Q&A – Treehaven Forestry Advancement Center RFQ

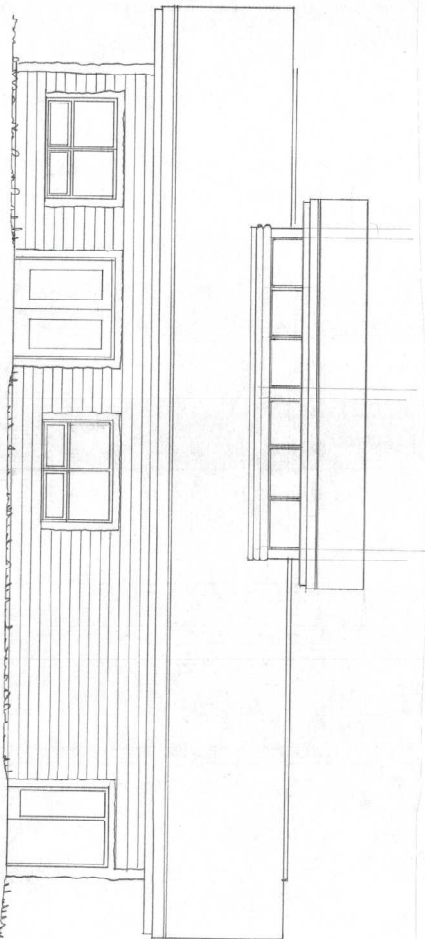
6. We read that a preliminary concept design has been completed for the project. Can this be shared prior to firm selection?
 - The relevant informant from the concept design is within the RFQ. Attached are the two options submitted to Campus. See Option 1 and Option 2 below.
